PRODUCT CHANGE NOTIFICATION

Bourns® Model SRN5040 Series Semi-shielded Power Inductors *Additional Source of Supply for Inductor Core & Design and Source of Supply Changes for Cover Tape and Reel*

IC23075

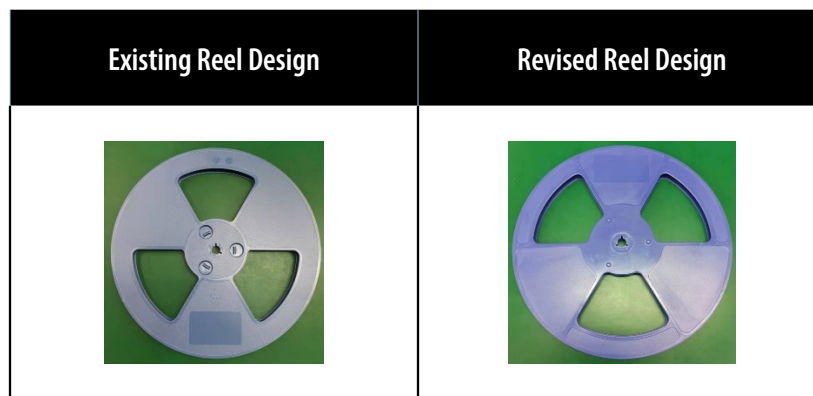
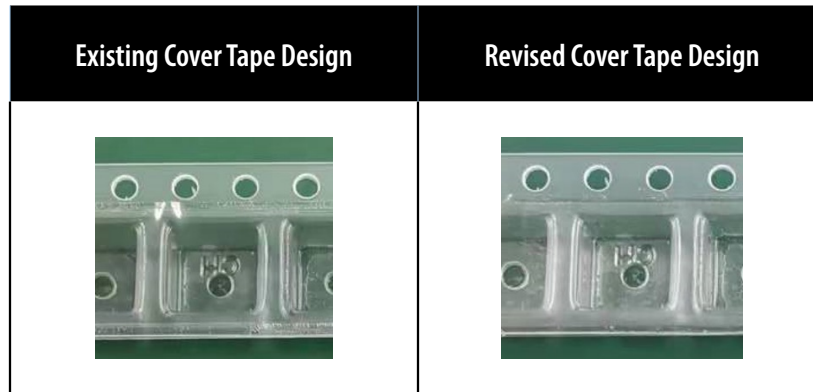
Bourns will also change the design and suppliers of the cover tape and reel for the Model SRN5040 Series Semi-shielded Power Inductors. The cover tape design will be changed from adhesive type to UCT type to improve the sealing quality. The reel design will be changed from assembly type to integral type for a more solid structure.
